**TOWN OF NEWBURGH  
PLANNING BOARD  
TECHNICAL REVIEW COMMENTS**

**PROJECT NAME:** GAS LAND PETROLEUM INC. – 42 South Plank Rd.  
**PROJECT NO.:** 2021-23  
**PROJECT LOCATION:** SECTION 71, BLOCK 2, LOT 11  
**REVIEW DATE:** 14 FEBRUARY 2022  
**MEETING DATE:** 17 FEBRUARY 2022  
**PROJECT REPRESENTATIVE:** CHAZEN COMPANIES/CHRIS LAPINE

**Re: Town of Newburgh Planning Board Project # PB21-23**  
*Proposed Convenience Store with Fuel Pumps*  
*Gas Land Petroleum, Inc.*  
*42 South Plank Road (Tax Parcel Section 71Block 2Lot 11)*  
*Town of Newburgh, Orange County, NY*  
*Chazen Project #82019.00*

**DEMOLITION PLAN**

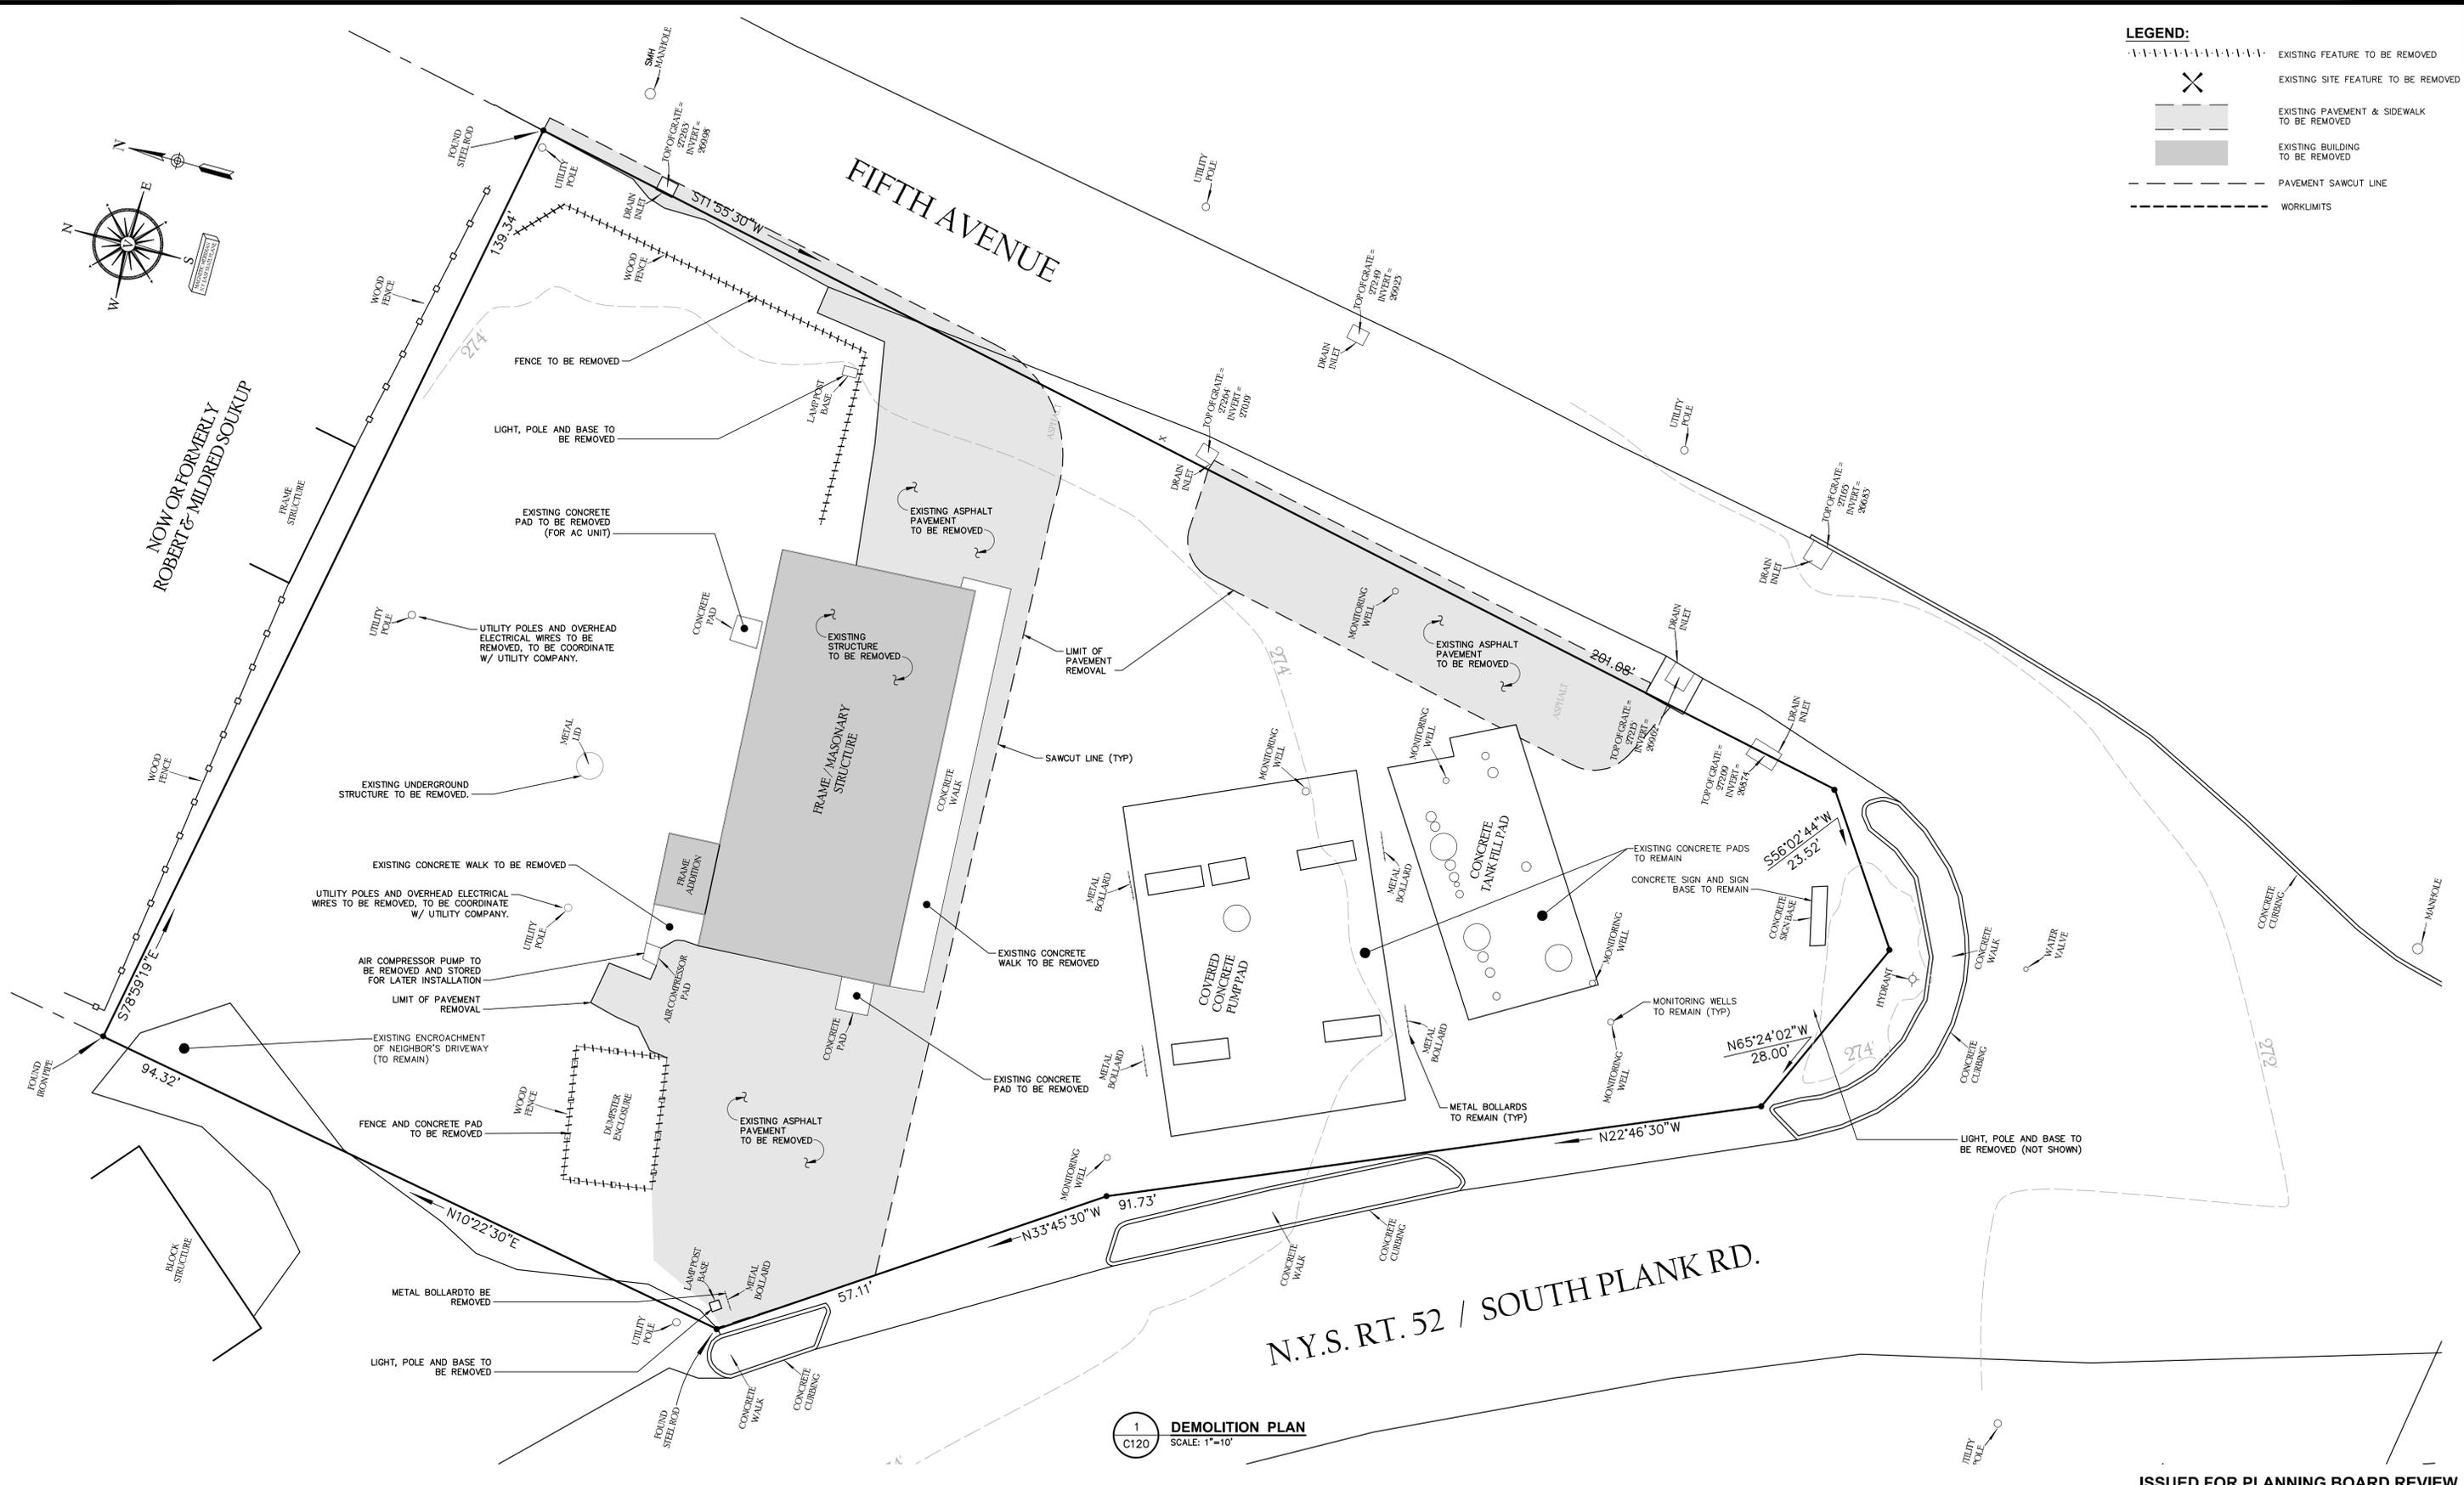
2. A Demolition Plan has been provided. Demolition Plans should contain notes requiring a Demolition Permit be issued by the Town of Newburgh Building Department prior to any demolition on the site.

GAS LAND - 42 S. PLANK ROAD (NYS ROUTE 52)  
**VEHICLE MANEUVERING PLAN**  
 TOWN OF NEWBURGH, ORANGE COUNTY, NEW YORK

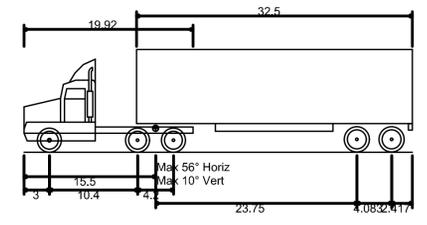
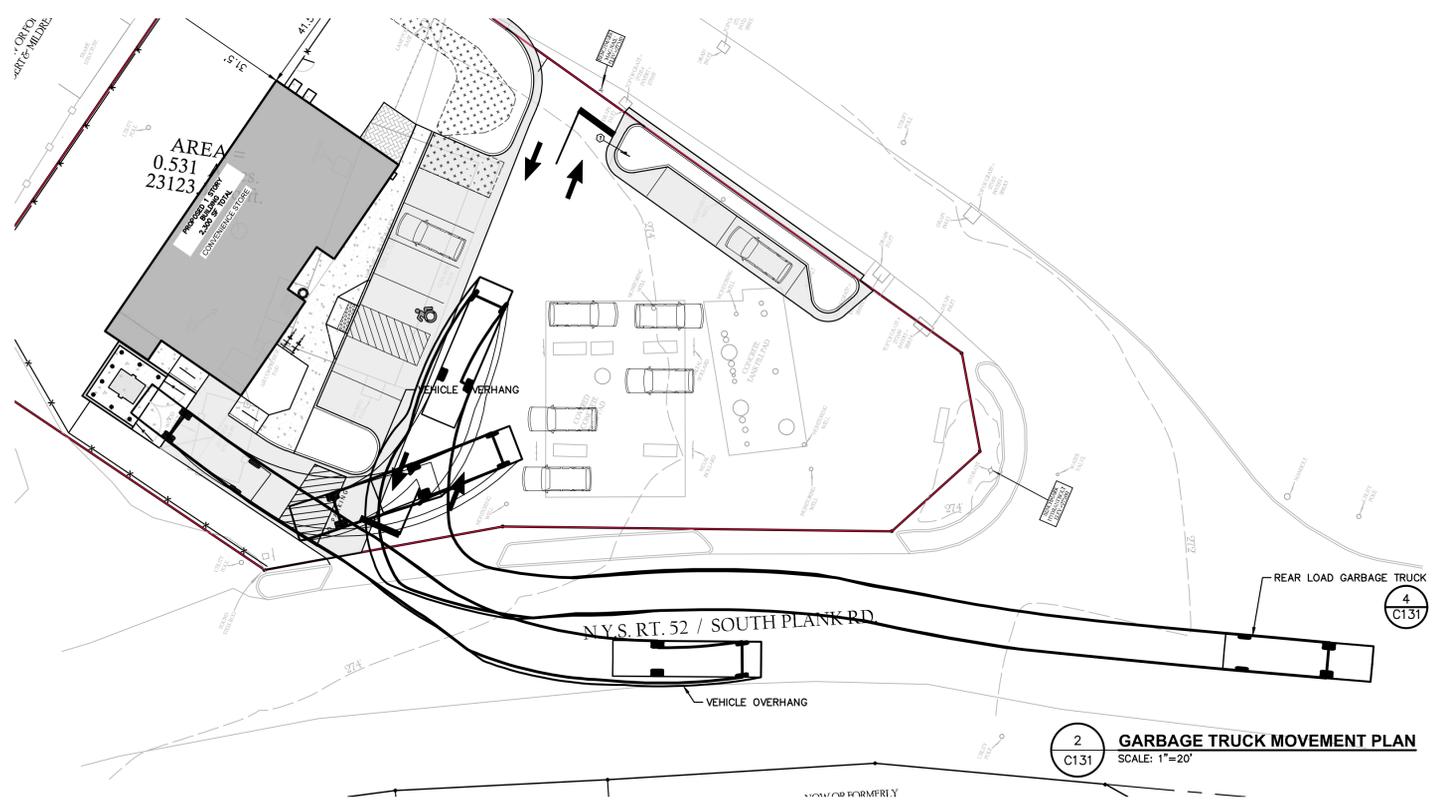
4. Ken Wersted’s comments on the size of the truck utilized for the turning template should be received. The gasoline tanker delivery trucks will be the largest accessing the site. The template appears to use a small truck.

**UTILITY PLAN**

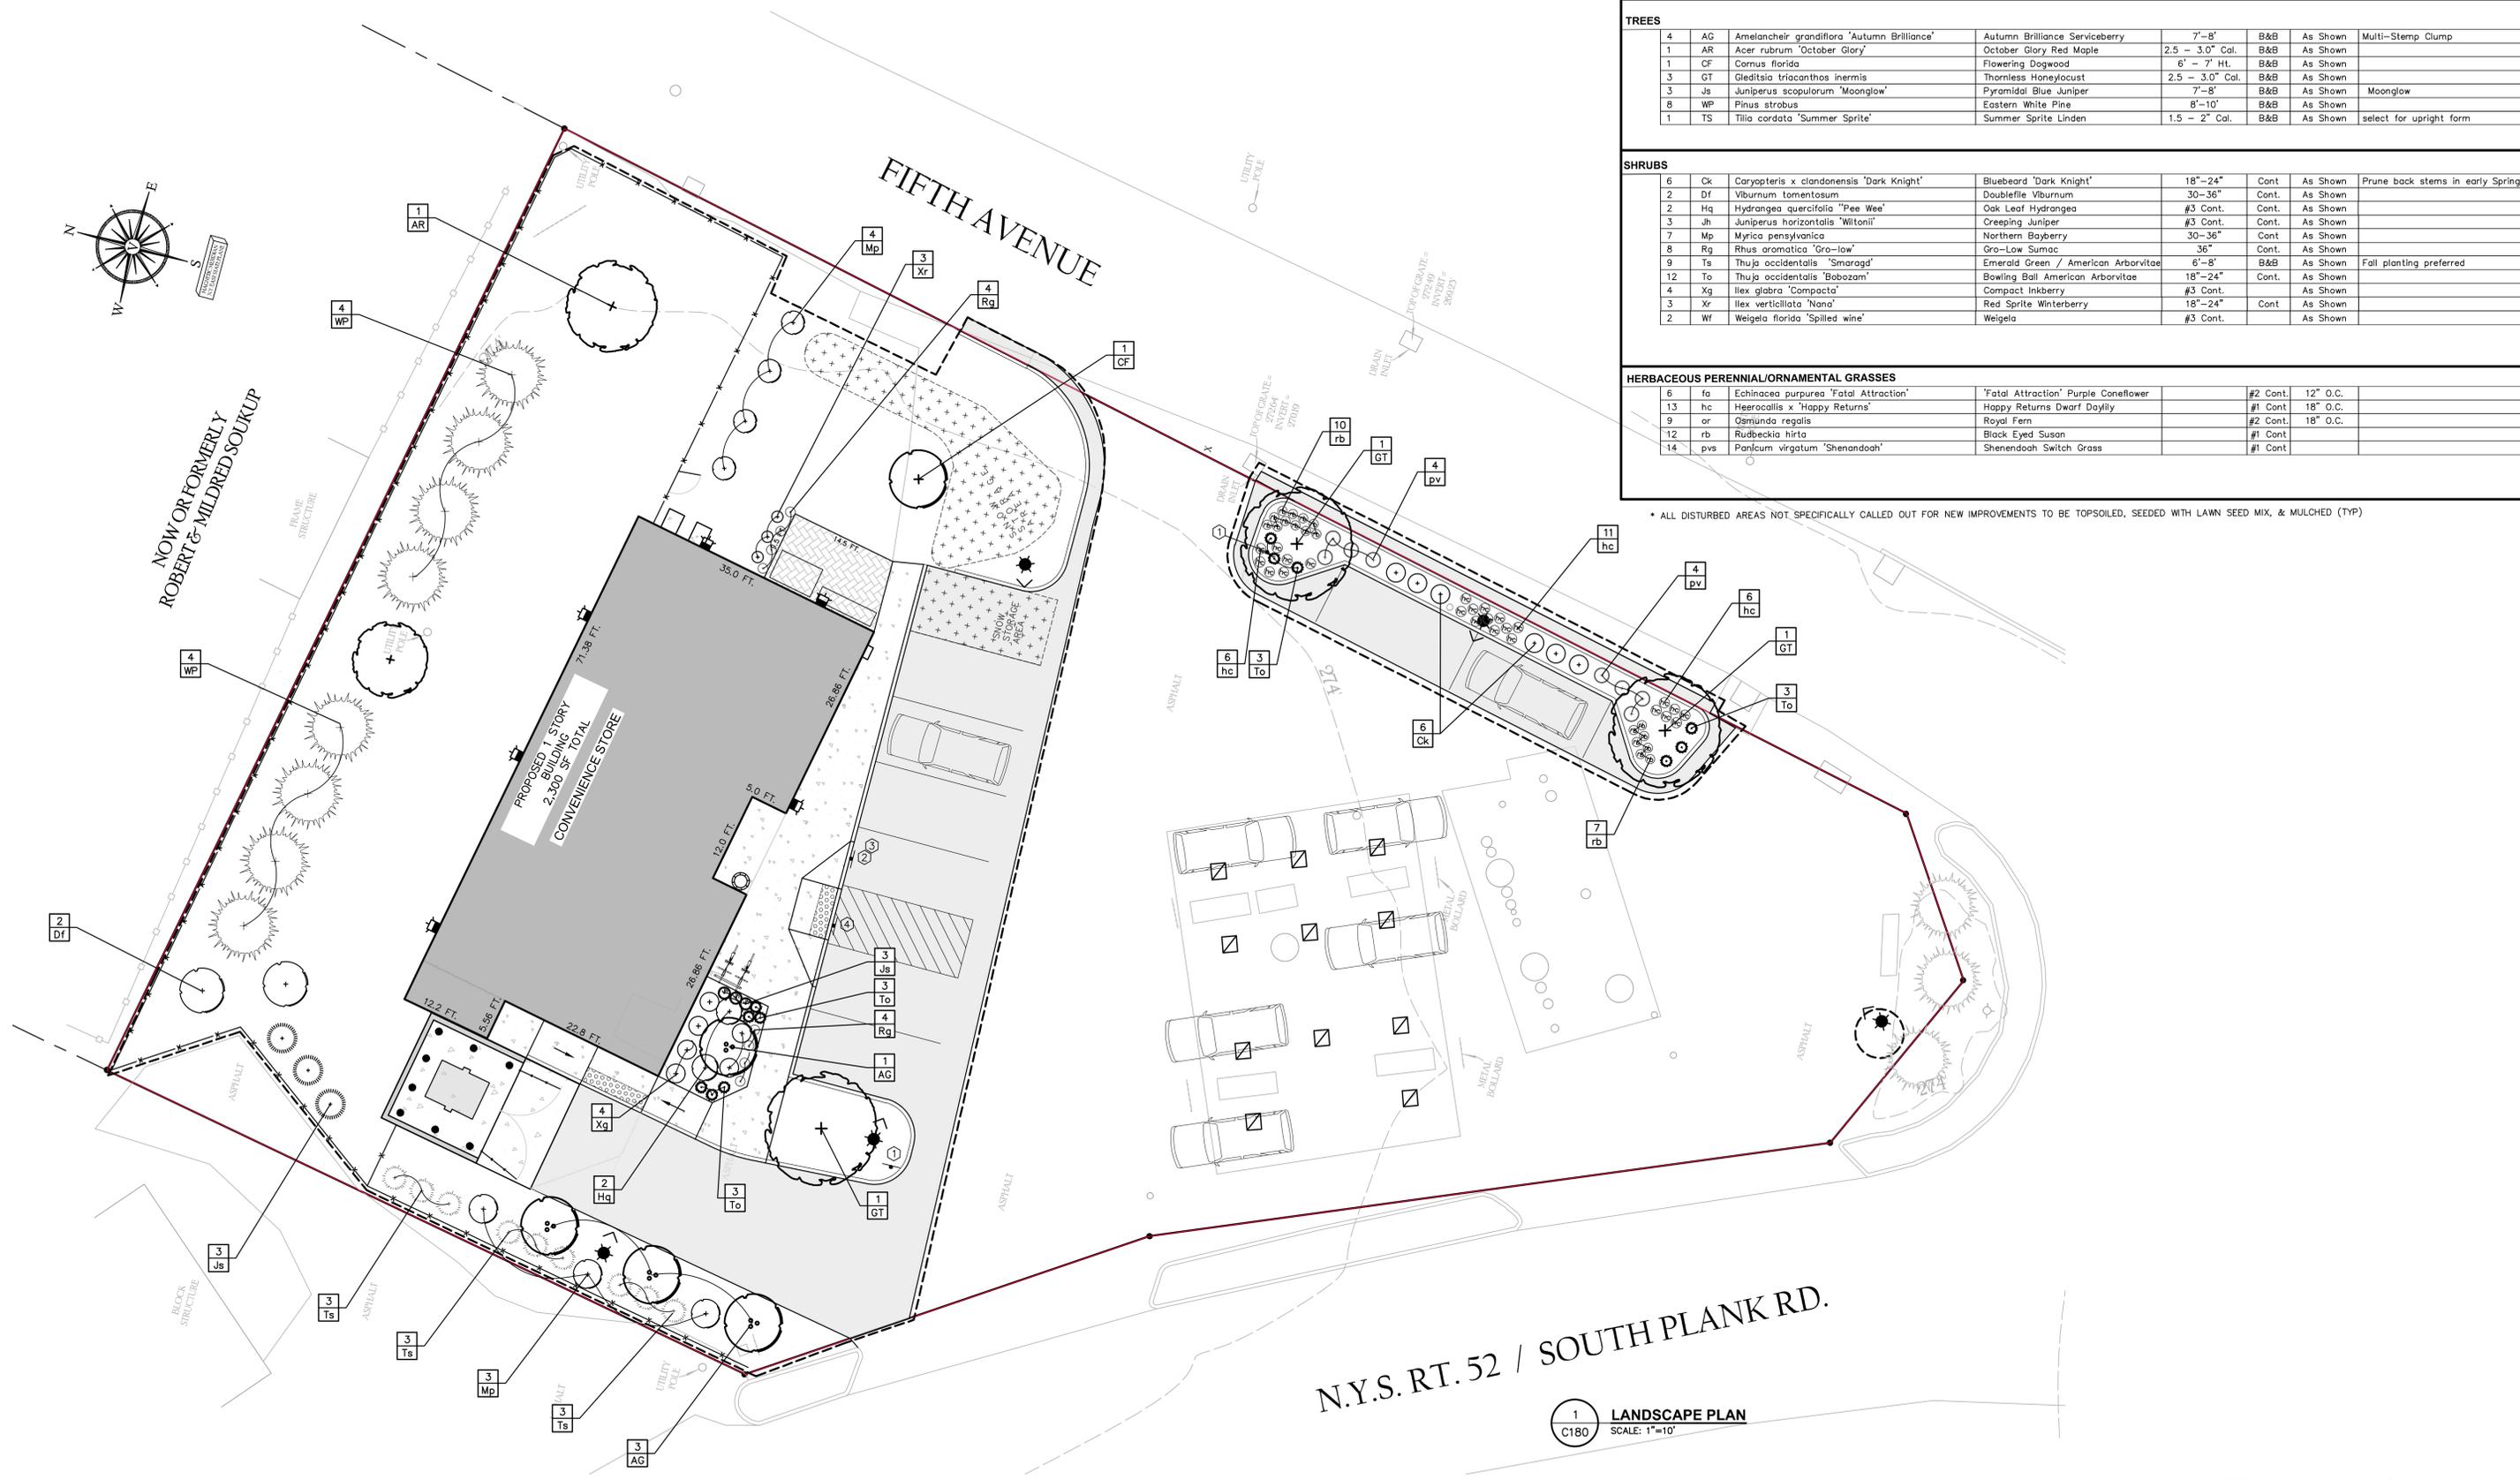
7. Size of the existing curb stop should be determined. Water Department records should be evaluated to determine size of the lateral. Newburgh water and sewer notes should be added to the plans. (Copy attached)

9. Sanitary manhole #1 identifies a west invert of 272.39. This pipe is not depicted on the plans. It appears a separate sanitary line may be proposed after the grease trap.
10. Show location of existing curb stop for proposed water line.
11. General Utility Plan note #3 regarding sewer mains identifies “where possible 10’ separation be provided”. Ten foot separation is required and any conflict to the vertical separation will also require Health Department approval.
12. County Planning referral is required as project is located along a state highway.
13. The Planning Board will need to determine if it wishes to hold a Site Plan Public Hearing for the project.

**PHOTOMETRIC LIGHTING PLAN**

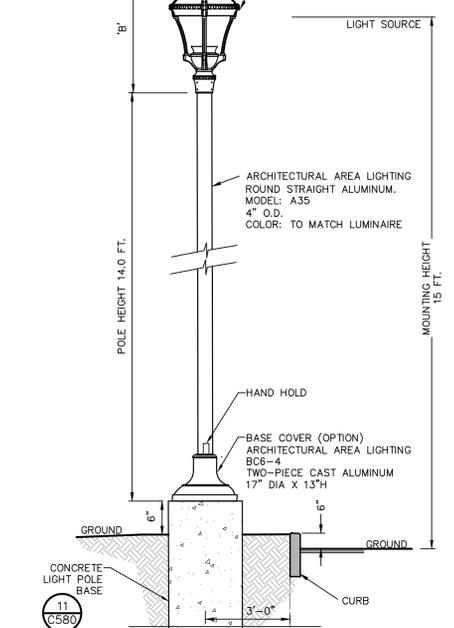
8. The applicants have proposed pedestrian scale lighting on the site in compliance with the design guidelines.
